Resolved Issues

Outstanding Issues

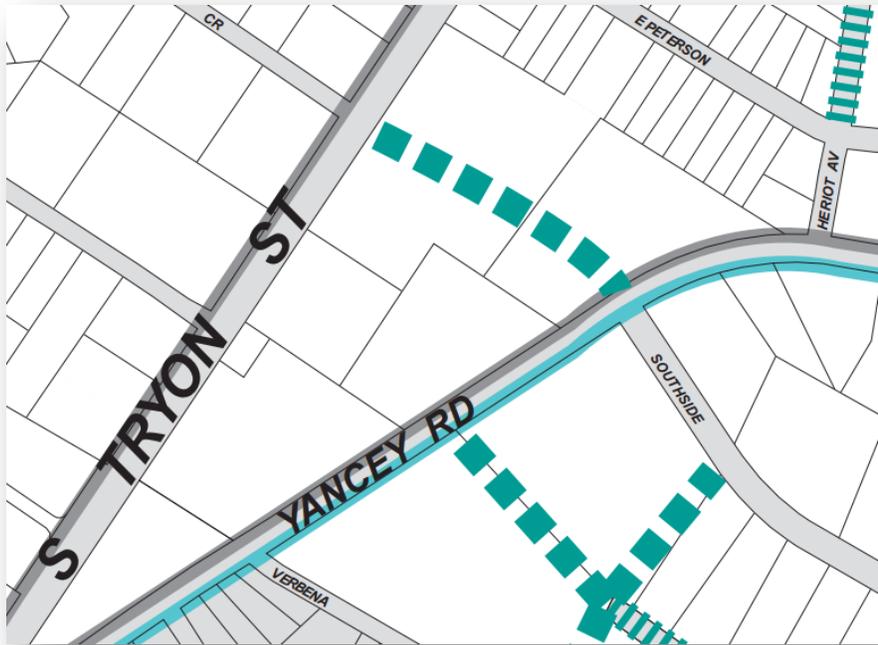
1. The petitioner should revise the site plan to show reconstruction of the three existing driveways along the Yancey Road frontage since the site plan already shows construction of new sidewalk along the property frontage on Yancey Road.
2. The petitioner should revise the site plan to add a note stating that the on-street parking spaces will not be striped. Showing the spaces on the plan for conceptual identification of available parking is acceptable.
3. The petitioner should revise the site plan along S. Tryon to match the Scaleybark Transit Station Area Plan. The future back of curb on S. Tryon St is 38' from the centerline of the roadway. The setback on S. Tryon needs to be measured from this future location. Petitioner should dimension 38' from centerline to future back of curb and required setback from future back of curb to future building.

1. The petitioner should revise the site plan to relocate the future manufacturing/office building so that it does not conflict with the future street connection from Yancey Road to Orchard Circle as identified in the Scaleybark Transit Station Area Plan.

Recommended note 3e revision:

New site access on Tryon shall be constructed in direct alignment within Orchard Circle (north) to create the fourth leg of this unsignalized intersection. This segment shall be 200' length (minimum) with a public street cross section and public access easement. A driveway connection to this fourth leg segment may be made to create vehicular access to the proposed Future Manufacturing Office Building if needed. In no case shall the proposed Future Manufacturing Office Building be in conflict with or at the terminus of this fourth leg segment.
